POCONO LAKE DAM  
MONROE COUNTY, PENNSYLVANIA

6 PHASE I INSPECTION REPORT  
NATIONAL DAM INSPECTION PROGRAM.  
Pocono Lake Dam  
Delaware River Basin, Monroe County,  
Pennsylvania. Phase I Inspection Report,

WOODWARD-CLYDE CONSULTANTS  
5120 Butler Pike  
Plymouth Meeting, Pennsylvania 19462

PHASE I INSPECTION REPORT  
NATIONAL DAM INSPECTION PROGRAM  
POCONO LAKE DAM  
NATIONAL ID #PA 00781  
DER #45-222

FIELD OBSERVATION PLAN  
POCONO DAM

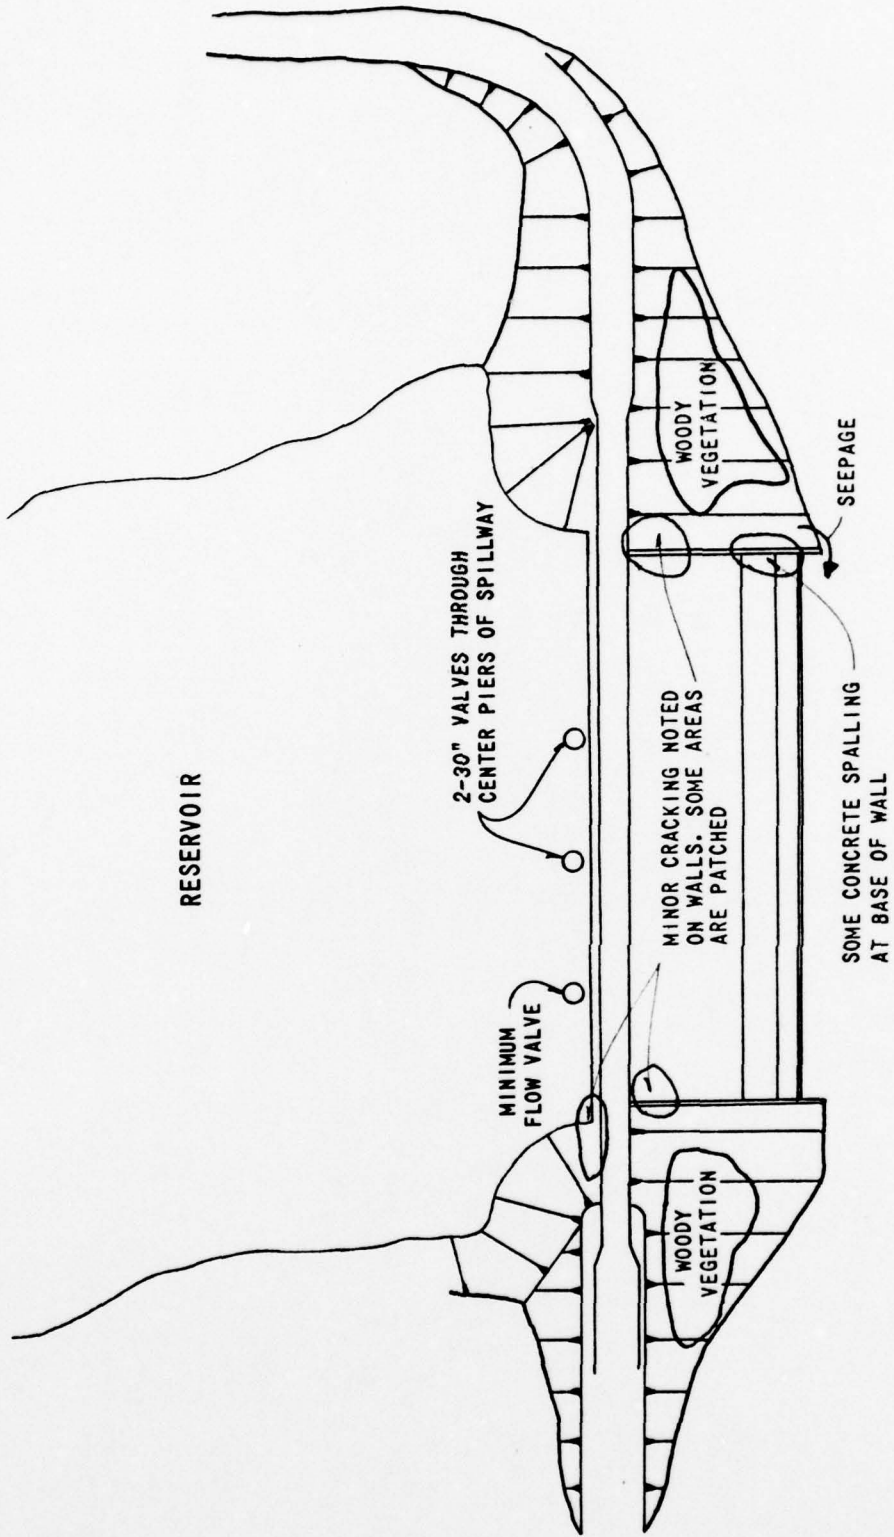
*See Sheet 5a, for seepage locations.*

*Some spalling noted at base of retaining walls as shown on Sheet 5a and photographs. This spalling should be repaired.*

PHOTOGRAPH NO. 8

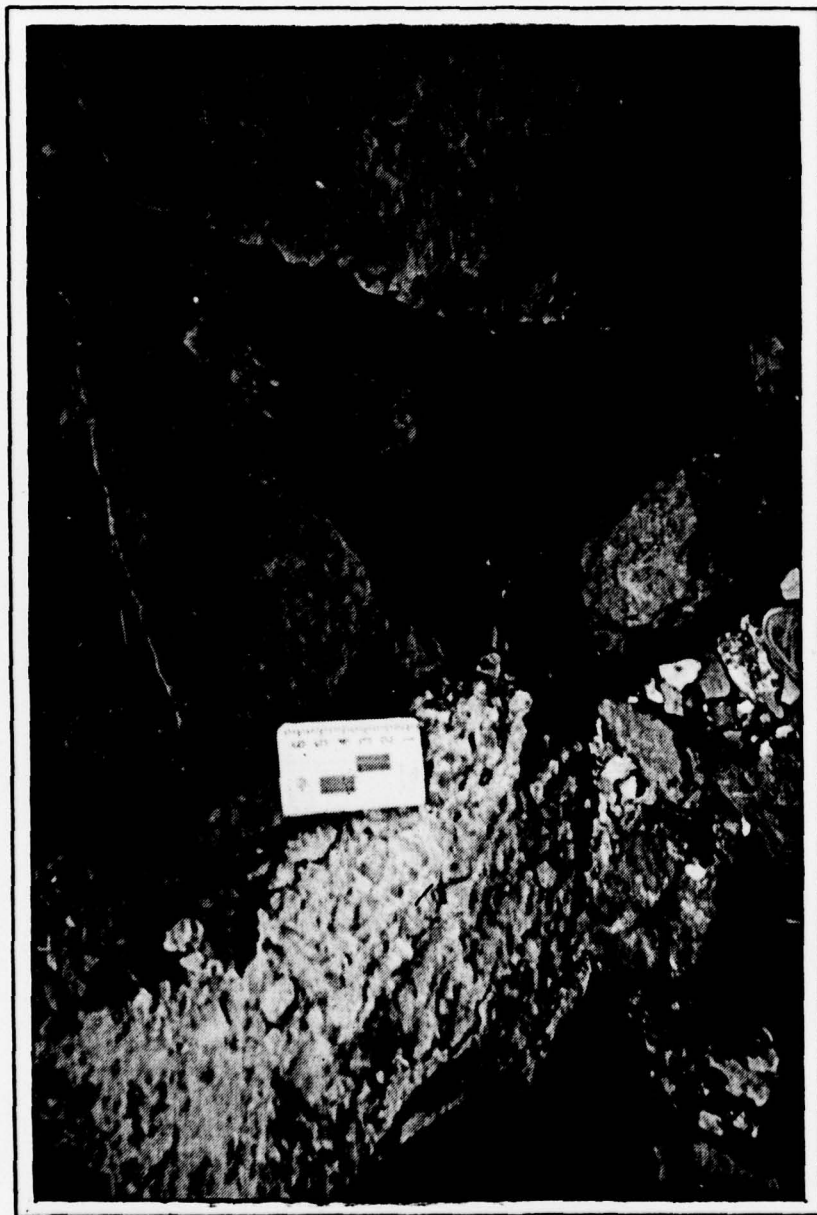
DIAGONAL CRACKING OF LEFT SPILLWAY  
WALL.

PHOTOGRAPH NO. 13

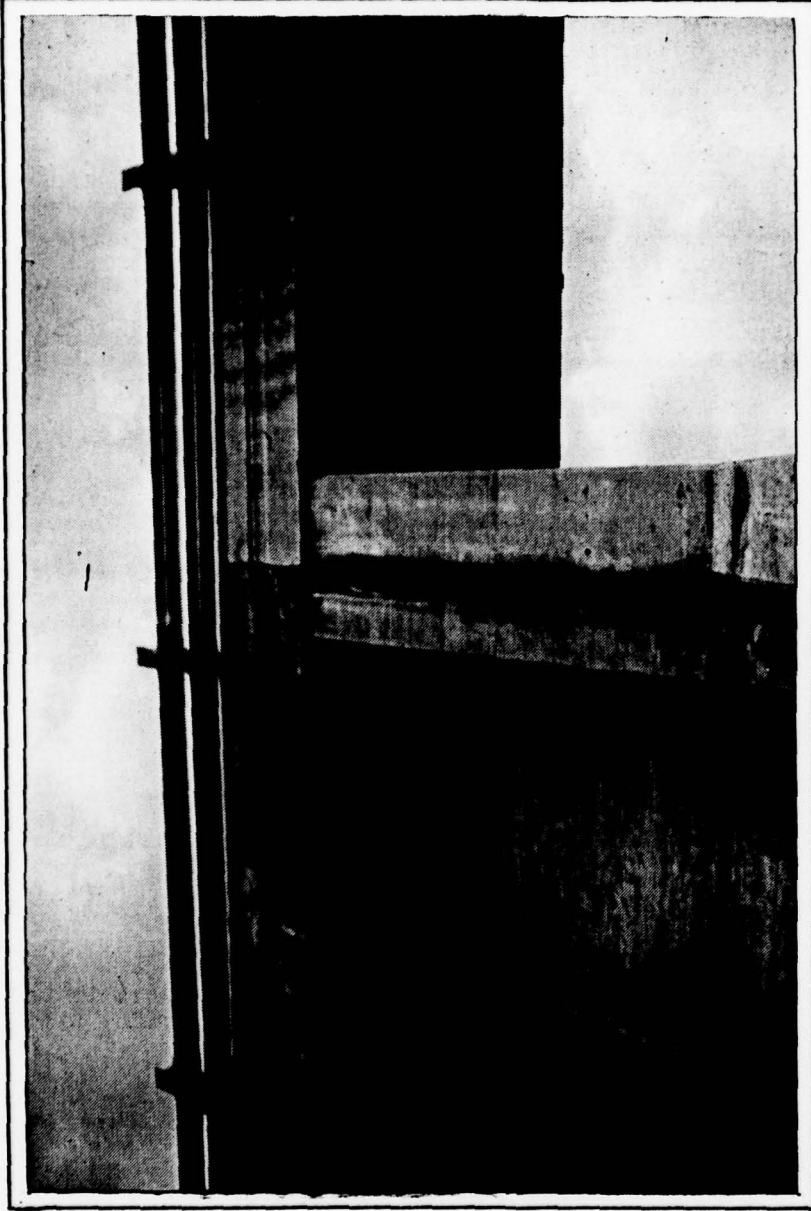
NOTE DETERIORATION OF BRIDGE  
ABUTMENT. REFER TO PHOTOGRAPH  
NO. 13 FOR LOCATION.
